MANDATORY SERVICE BULLETIN NO. MSB 40NG-077 REV. 0

Inspection of gearbox oil.

WORK INSTRUCTION WI-MSB 40NG-077 REV. 0

Figure 1. Location of the placard.

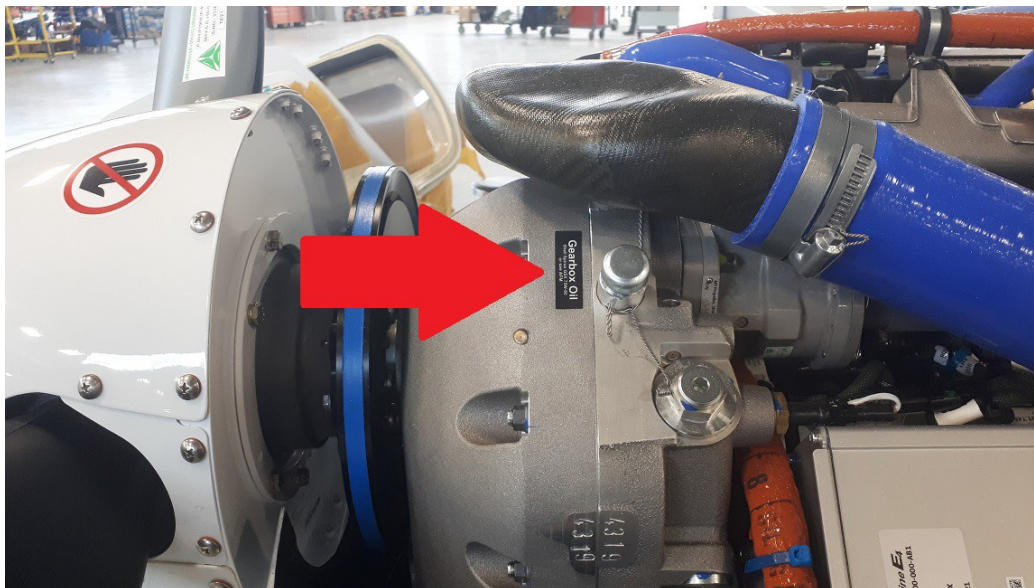
1. Ensure the engine is safe.
2. Remove the engine cowlings. Refer to AMM Section 71-10.
3. Inspect the placard located near the gearbox oil fill plug. Refer to Figure 1.

Figure 2. Correct gearbox oil placard.

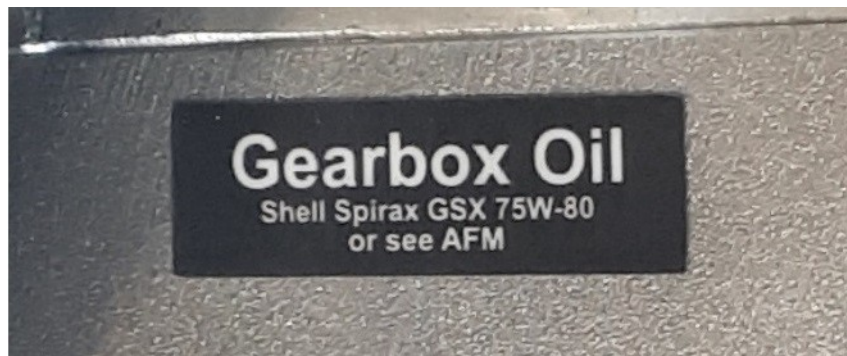
4. If the placard on the gearbox matches the placard in Figure 2, proceed to step 7.

5. If the placard currently installed on the gearbox does not match the placard shown in Figure 2, replace the placard with placard P/N D64-1126-20-27:

- A. Remove the currently installed placard.
 - B. Thoroughly clean the area where the placard was installed. The surface must be free from contamination.

- C. Apply the new placard. Take care when positioning the placard. Attempting to reposition the placard may damage the placard.
6. Review the aircraft logbooks and determine the gearbox oil used during each service. If the gearbox was serviced with oil not listed in the DA 40 NG AFM Doc. No. 6.01.15-E, or if there is doubt regarding the gearbox oil being used, proceed as follows:
